RECEIPT DATE: 4/5/18 **ONSITE SEWAGE DISPOSAL SYSTEM** P 562950  
 APPROVAL DATE: 6/1/18 **PERMIT: CONSTRUCTION** A \_\_\_\_\_  
 PROPERTY ADDRESS: 15309 Galaxy Drive  
 SUBDIVISION: Fairlane Farms LOT: 3 TAX ID: \_\_\_\_\_  
 CONTRACTOR: South Carroll Backhoe EMAIL: sbackhoe@comcast.com  
 CONTRACTOR ADDRESS: 4410 Salem Bottom Road, Westminster, MD 21157 PHONE: 410-596-3618  
 PROPERTY OWNER: NV Homes EMAIL: \_\_\_\_\_  
 OWNER ADDRESS: 9720 Patuxent Woods Drive, Columbia, MD 21046 PHONE: 410-379-5956  
 SEPTIC TANK SIZE (GALLONS): 2000 TANK MANUFACTURER: Babylon Vault or equivalent  
 PUMP MODEL: N/A PUMP SIZE N/A PUMP TANK CAPACITY: N/A

Re: <b>Fairlane Farms, Lot 3</b>	W.O.# <b>05106-3003</b>
Date: <b>Feb. 7, 2018</b>	Pages: <b>0</b> Page(s) including this cover

**SEPTIC SYSTEM  
INSTALLATION SITE PLAN  
LOT 3**

15309 GALAXY DRIVE  
FAIRLANE FARMS

**SEPTIC PROFILE**  
SCALE: 1" = 30'

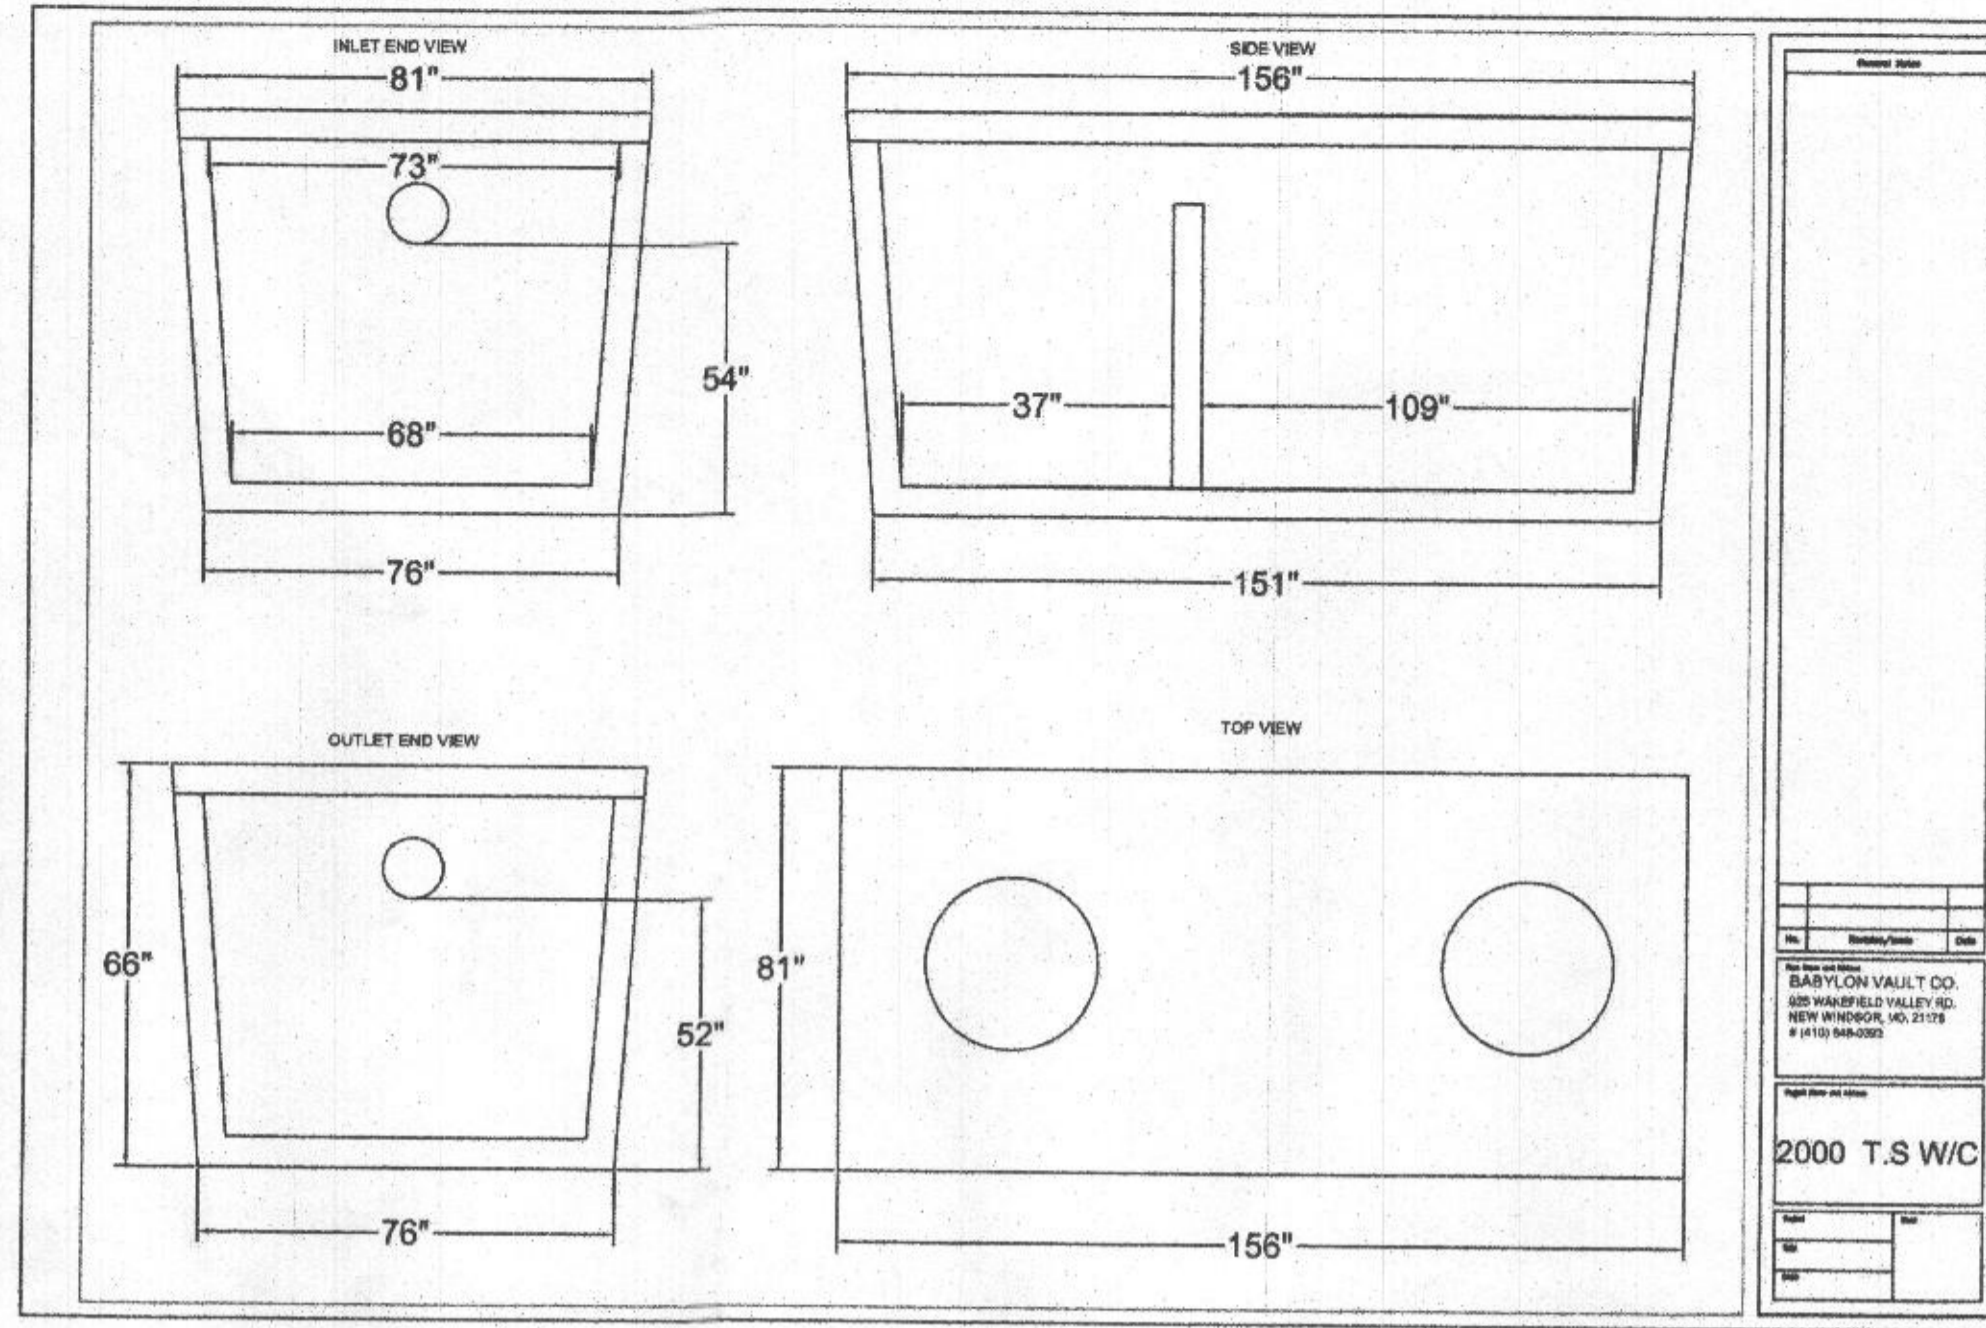
The invert elevations do not match exactly but I can redline them. Please see septic profile elevations and the list of elevations to the right of the profile. For example, invert elevation out of the house and the cleanout elevations do not match exactly.

**Here are 3 new copies (house has been rotated so that the front porch is outside the 30 ft. well box radius. There was no change in the length of sewer pipe, inverts, or grade over (no change to the profile). Hopeful you can approved this. Please let me know if you have any questions.**

**INITIAL TRENCH DETAIL**  
SCALE: 1" = 2'

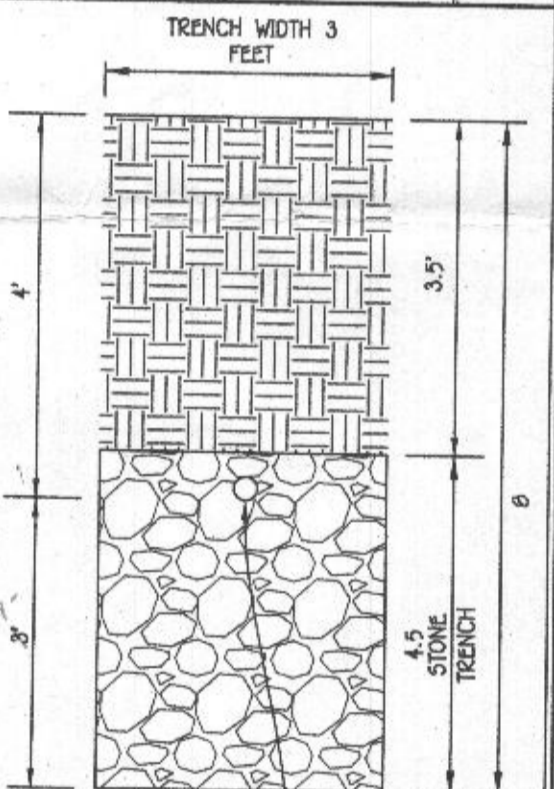
Also, trench detail total depth is 8 feet not 7. I can adjust this too.

Is the front porch on footers or is it a concrete slab (must meet 30 foot setback)? Also, may I redline the trench detail and make it 8 feet with 4.5 feet of stone? Also, Is the BSE = 592.88?
